**The W Nursing School
Neshoba General
Philadelphia, MS**

Addendum No. 2

June 10, 2026

This addendum forms a part of the contract documents and modifies the original plans and specifications dated June 4, 2026.

sheet no.
C-103

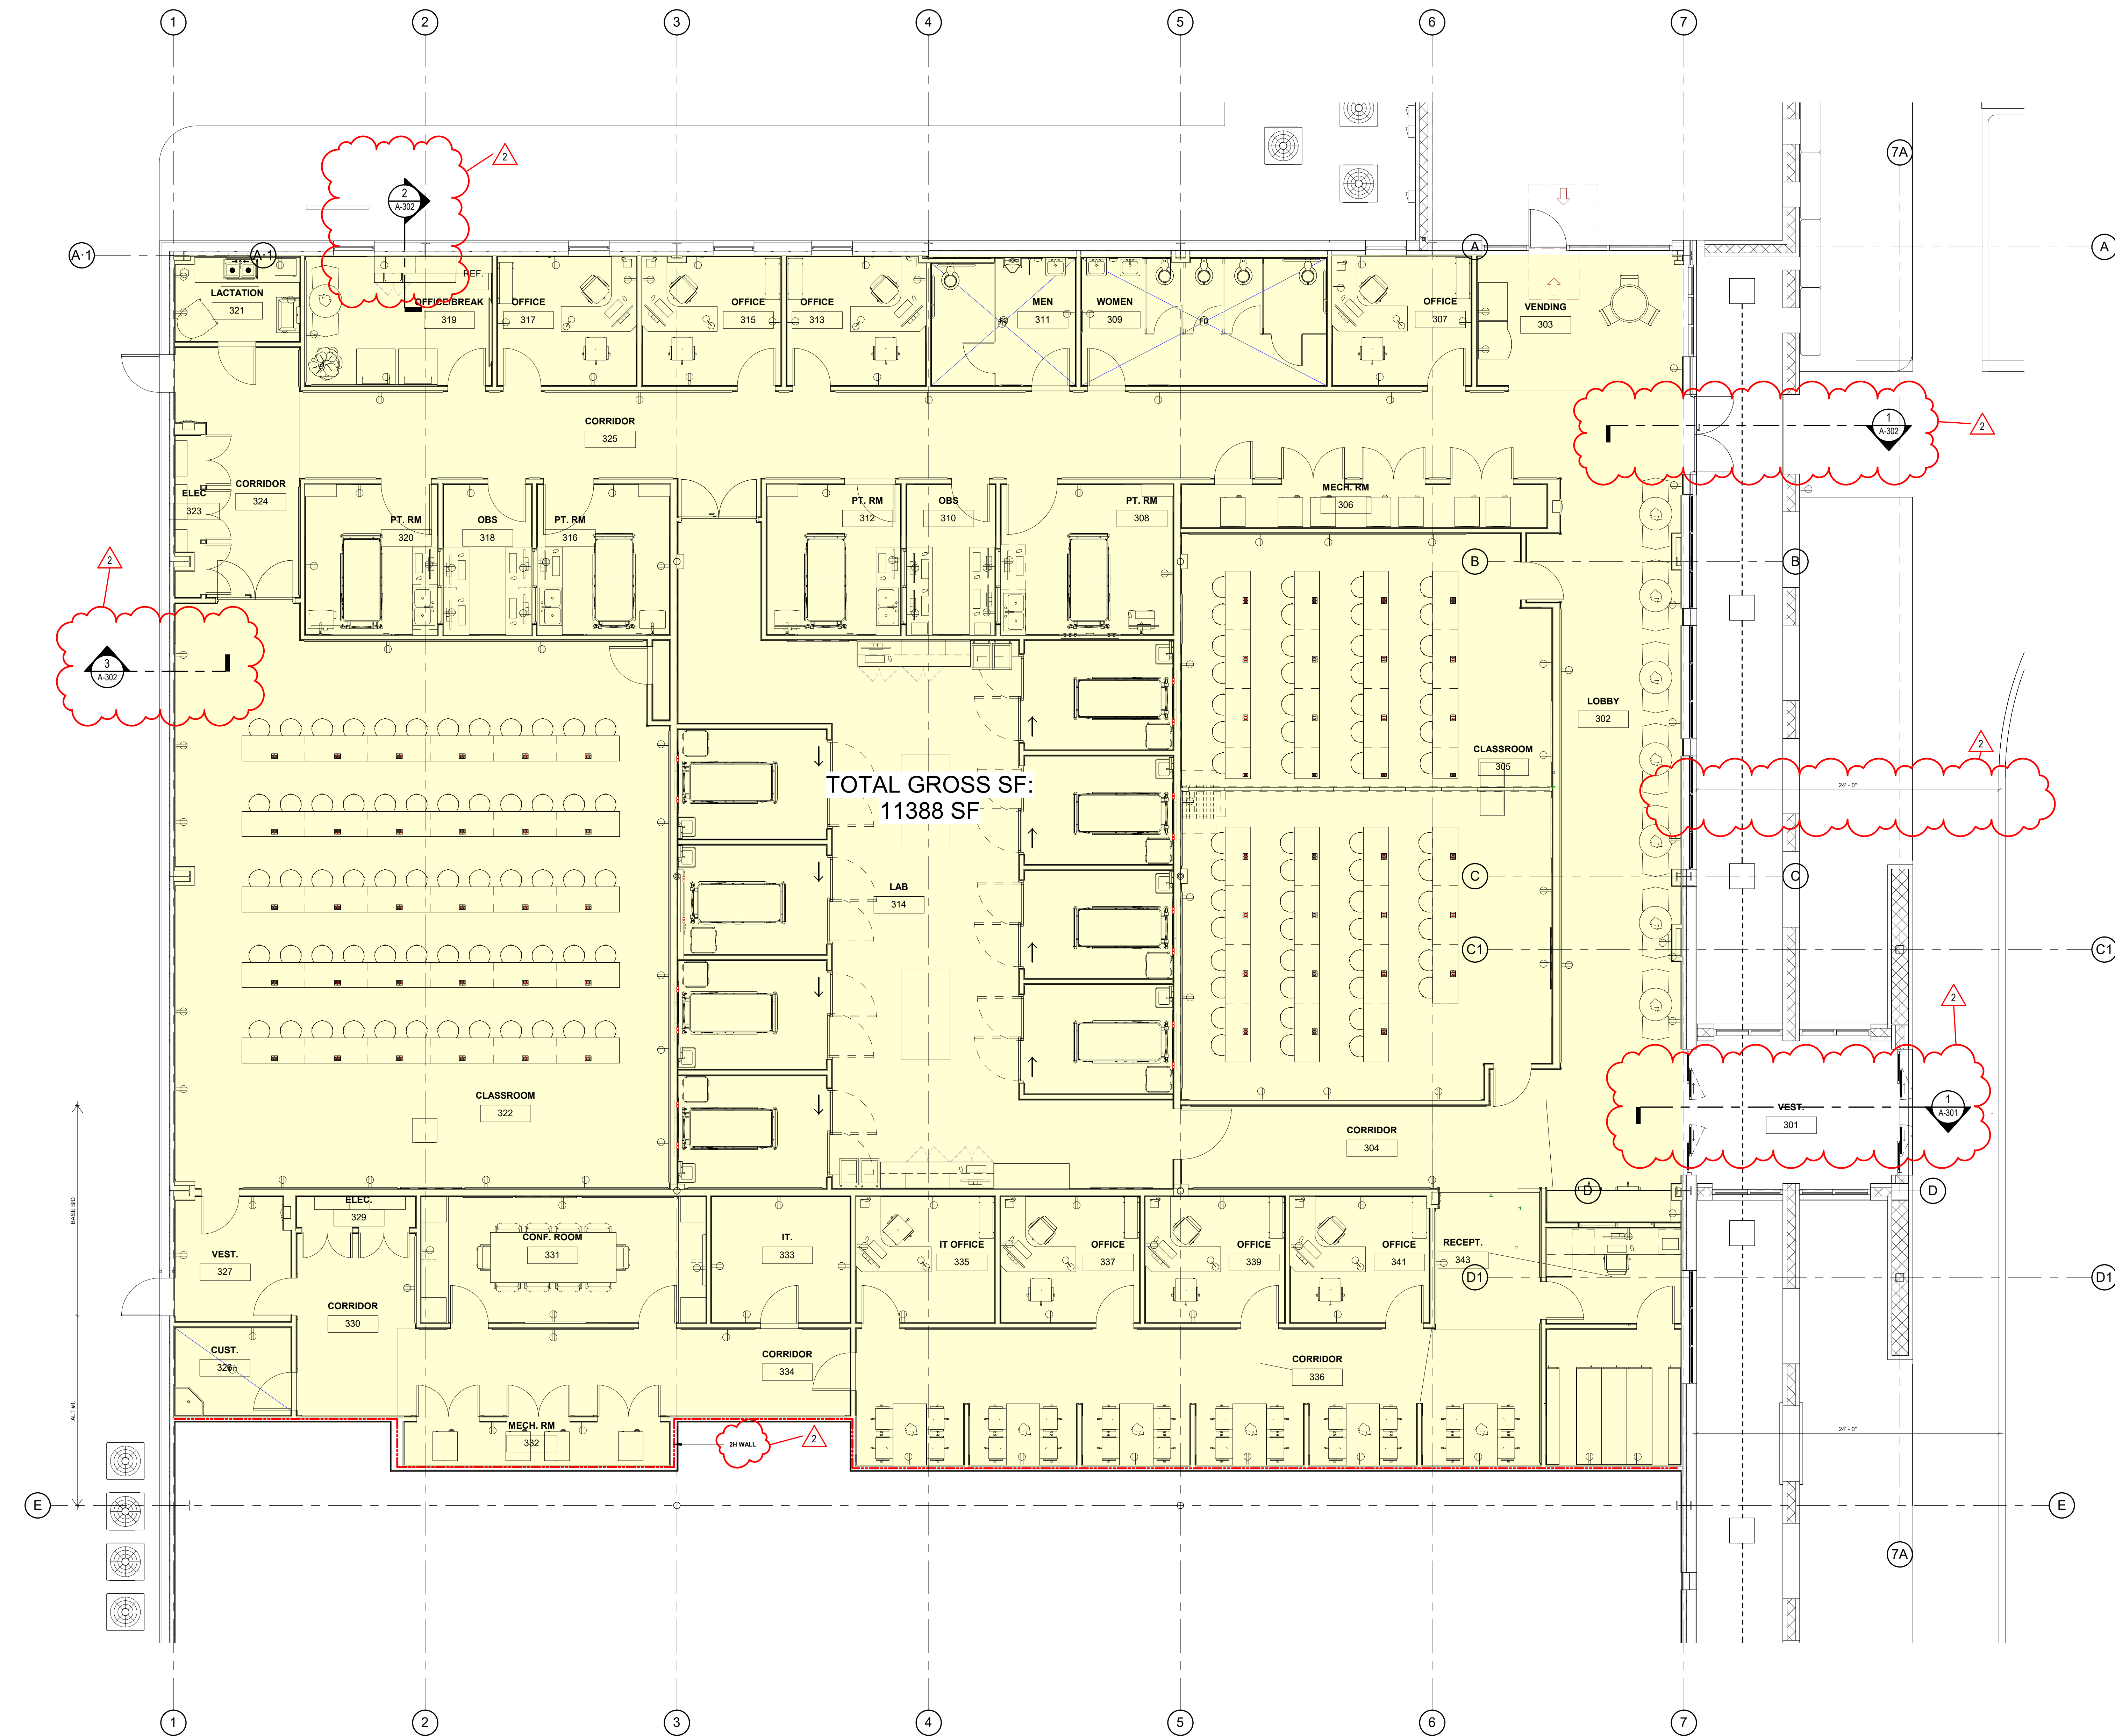
Item 2.1: Sheet C-103

Note: See Site Plan for corrected elevations. See curb schedule for corrected elevations.

sheet no.
A-101
of

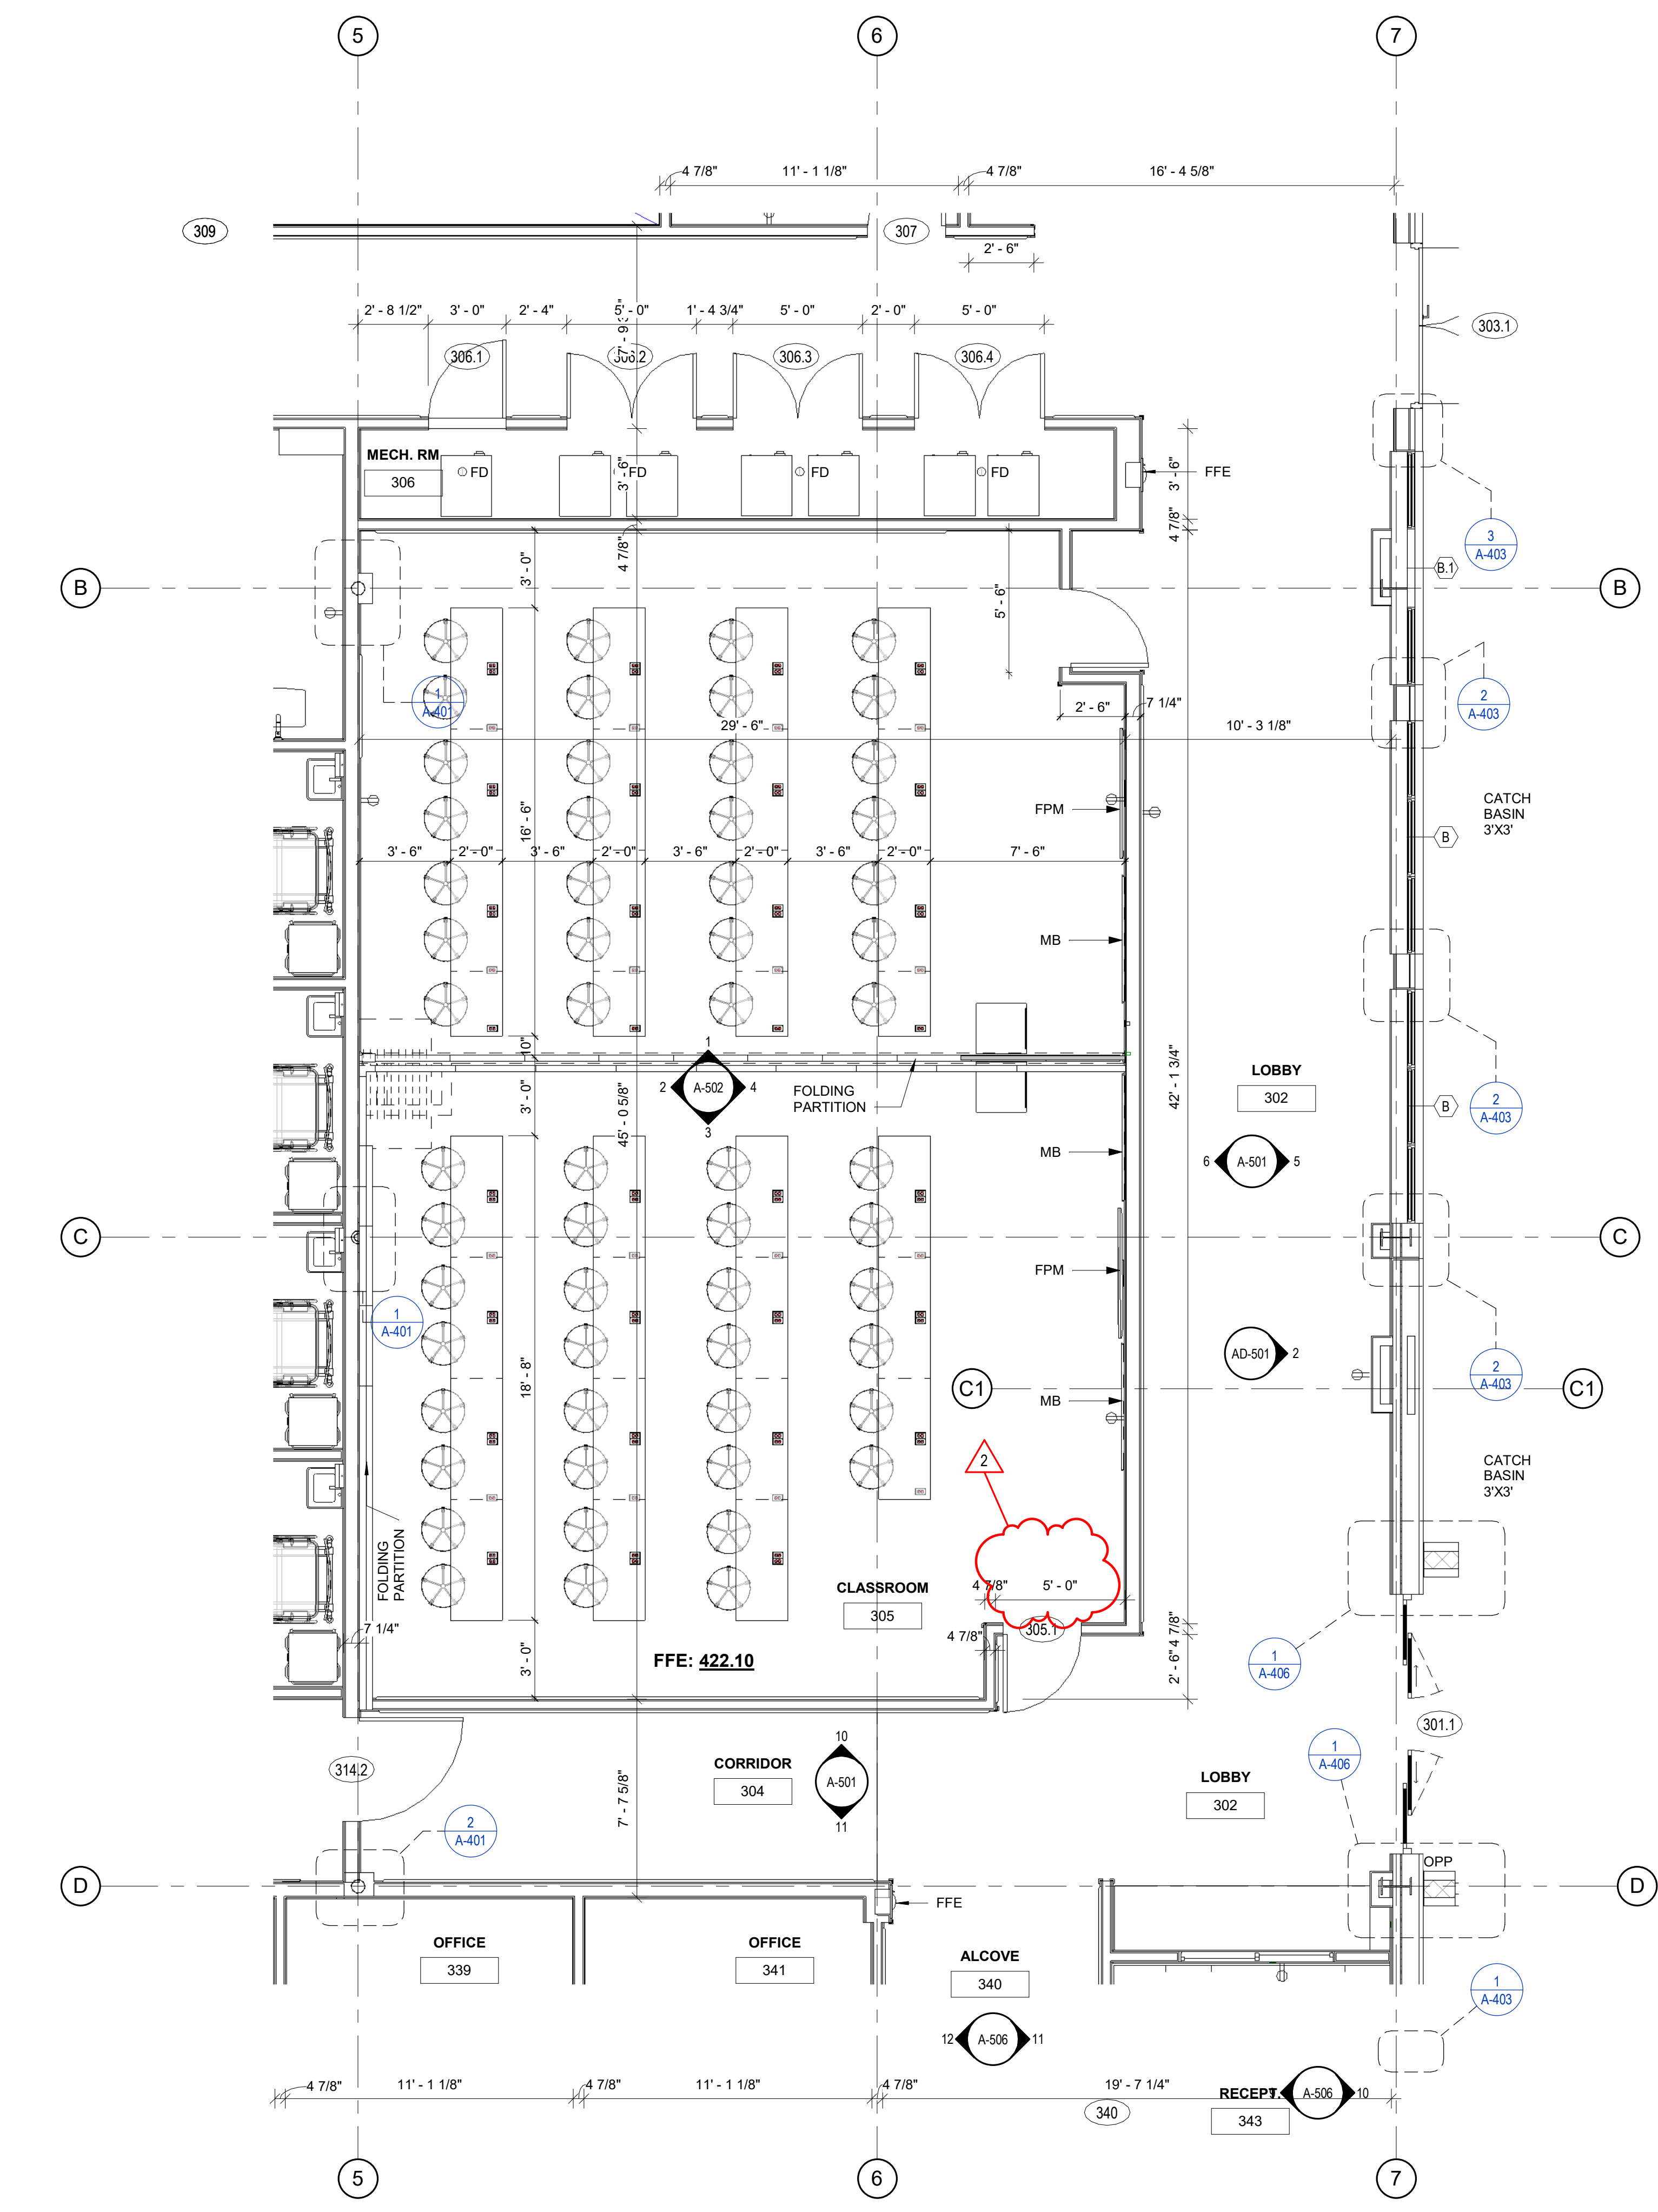
Item 2.2: Sheet A-101

Note: See clouded notes for exterior wall referenced sections.

sheet no.
A-103
of

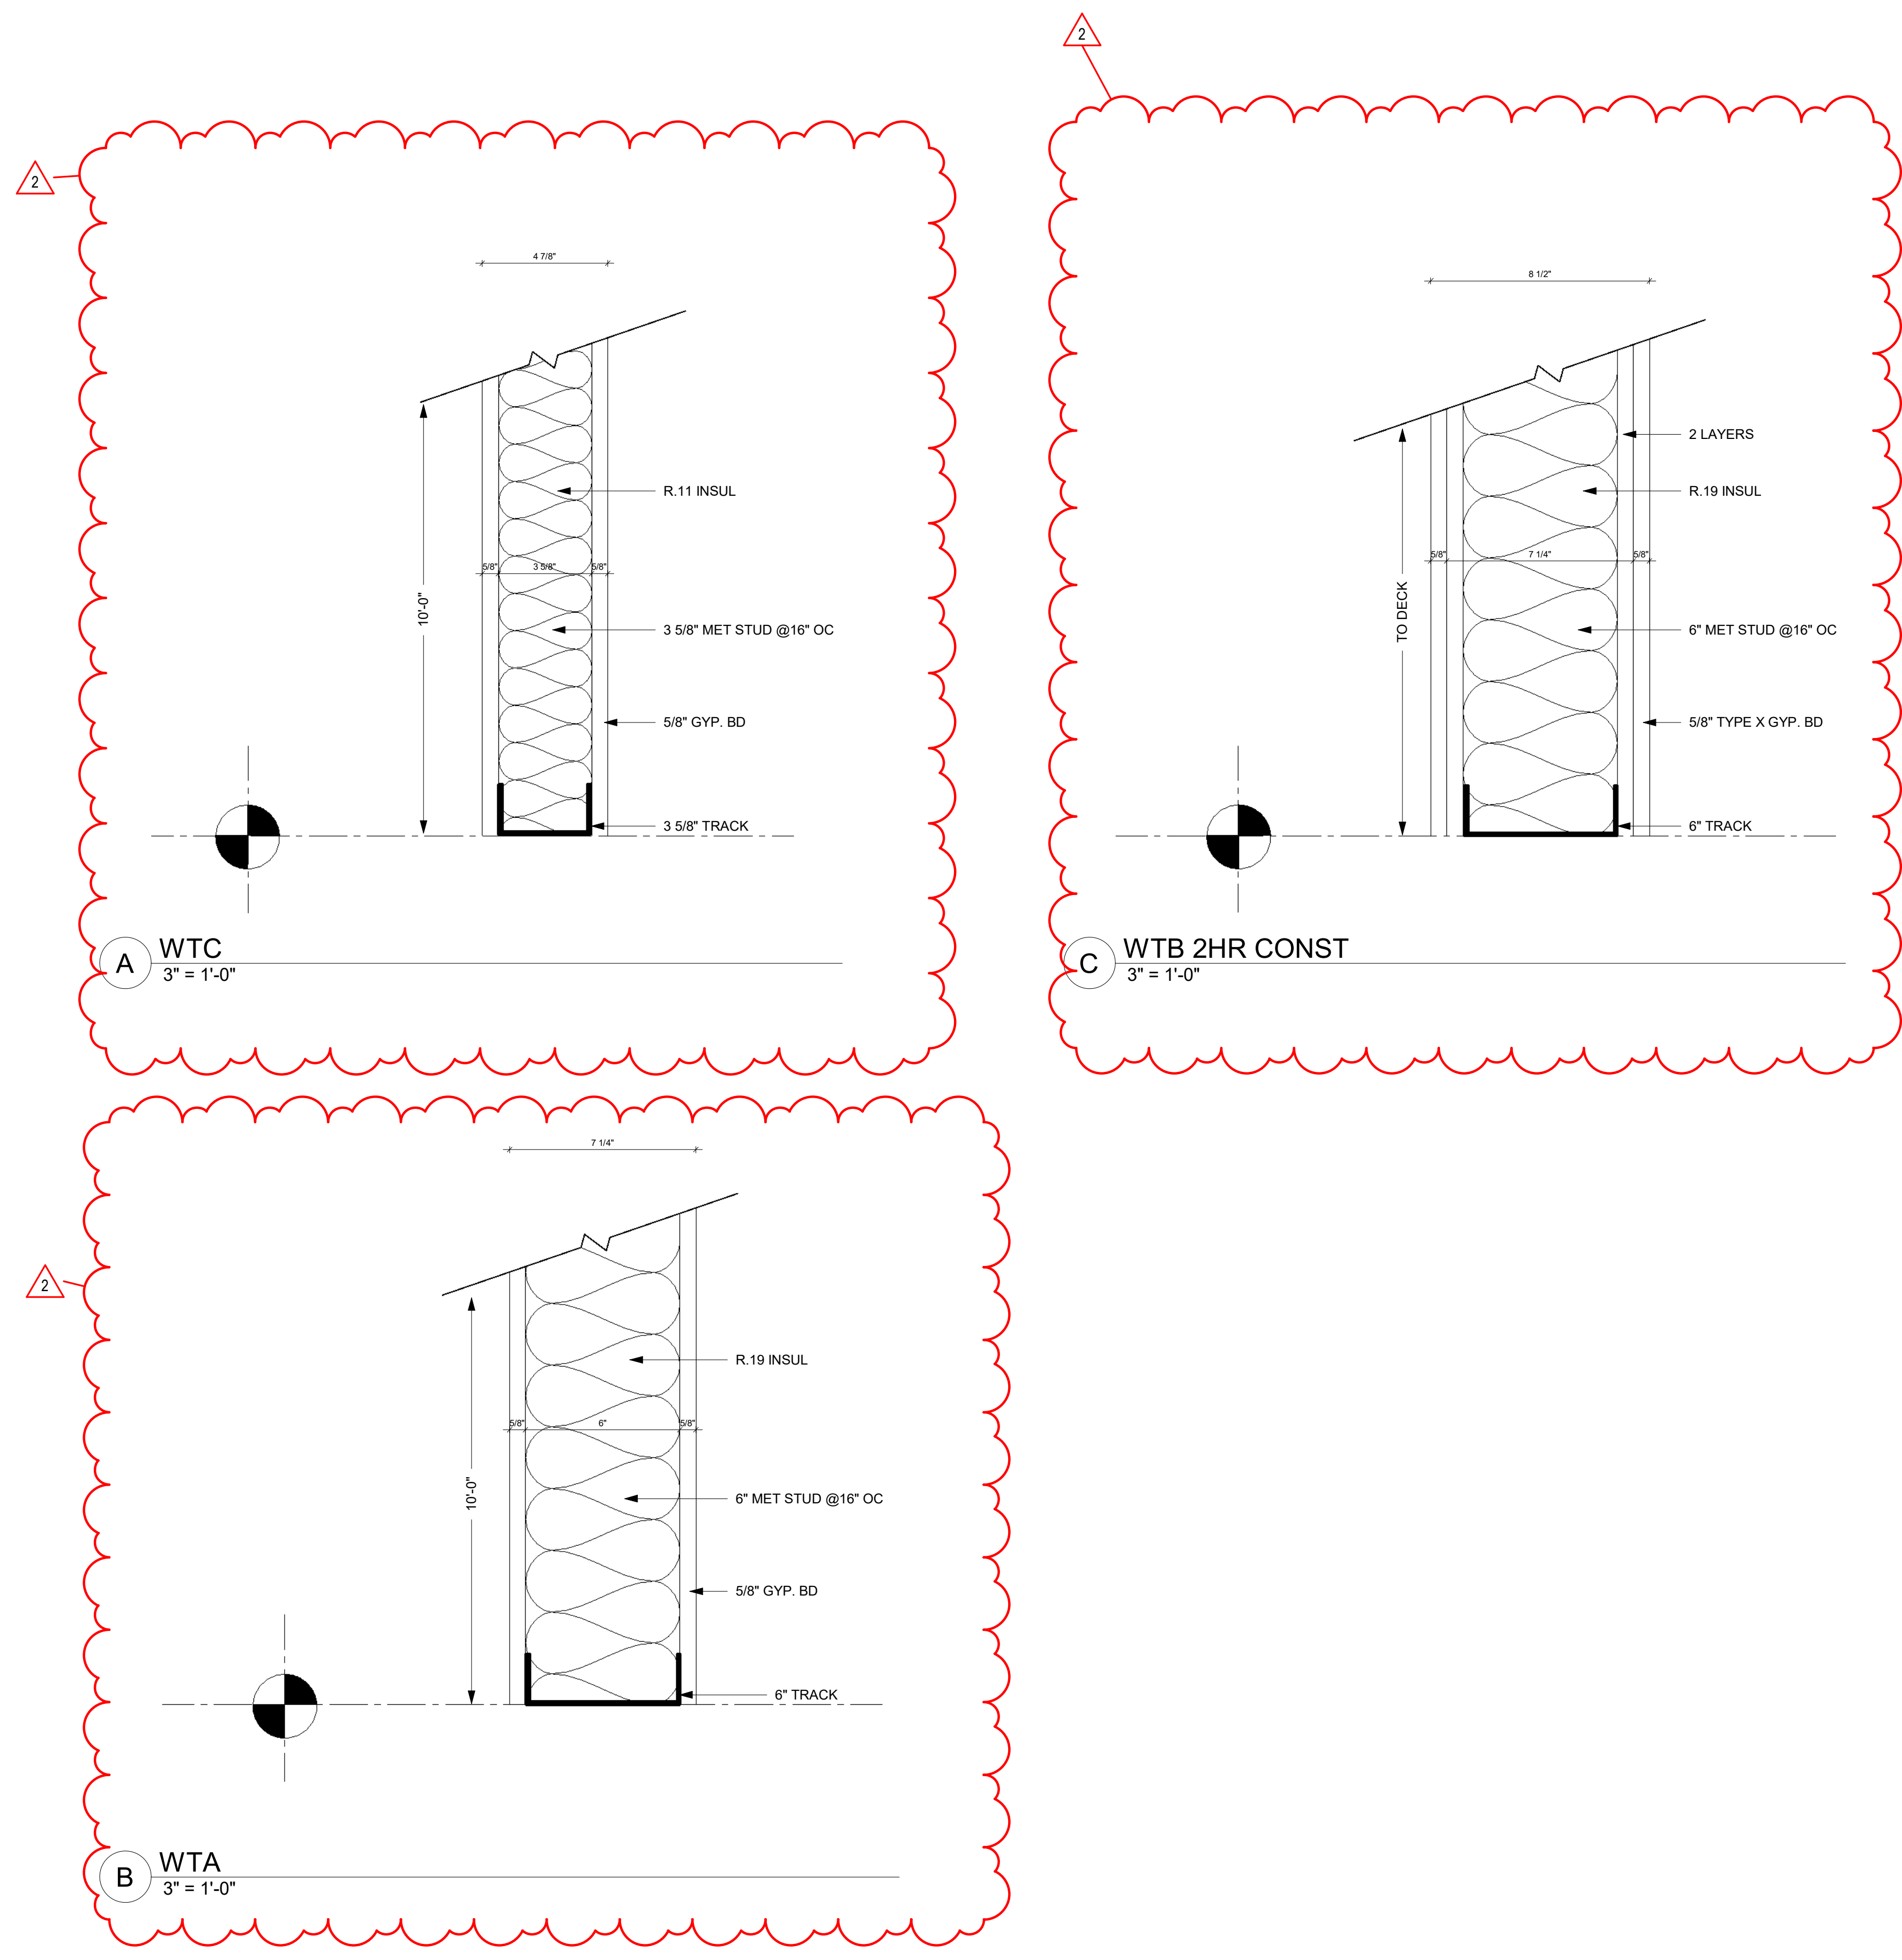
Item 2.3: Sheet A-103

Note: See clouded notes for dimensions at Room 305. See details 2, 3, and 4 for partition construction A, B, and C.
